UNITED STATES PATENT AND TRADEMARK OFFICE

| APPLICATION NO. | FILING DATE | FIRST NAMED INVENTOR | ATTORNEY DOCKET NO. | CONFIRMATION NO. |
|-----------------|-------------|----------------------|---------------------|------------------|
| 10/522,876 | 02/02/2005 | Mitsuo Tashiro | FP3002-0036 | 5251 |

| Office Action Summary | Application No. 10/522,876 | Applicant(s) TASHIRO, MITSUO | |

Annotated Figure 1: Huber '847

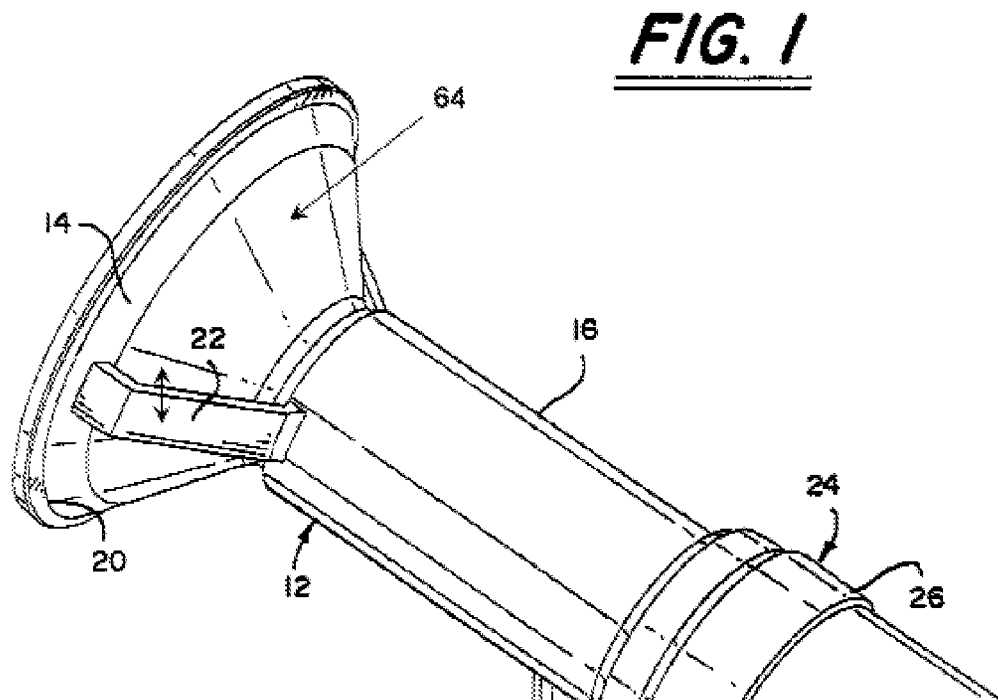
10. The Applicant argues that Huber '847 does not teach or suggest a space between the deformable member and the horn member.

11. In response to the Applicant's arguments, the Examiner notes that as shown in the annotated Figure 1 below, the arms of the horn member (22) are disposed over the

deformable member (60; at the surface area of 64). As indicated by the double arrow below, there is a space shown between the inner surface of the arms (22) and the outer surface of the deformable member (64). This space reads on the applicant's recitation of "a space between the deformable member and the horn member. Under application of negative pressure this space changes in volume as the outer surface of the deformable member (64) is deformed inwardly towards the breast under the force of the negative pressure. The inner surface of the arms (22) do not move because they are rigid – thus, a change in volume and spacing between the two elements occurs under negative pressure and returns to normal spacing upon release of negative pressure. The examiner further comments that the applicant has not in the independent claims provided structural recitations in the claims that describe the size, shape, or relative placement of the vent openings, size of the horn member relative to the deformable member, or size of the spacing between the horn member and the deformable member. Some aspects have been claimed in newly submitted claims 25-27 and the examiner recommends further detailing such aspects of the applicant's claim invention and incorporating the limitations into the independent claims to distinguish the applicant's claimed invention over the prior art of record.
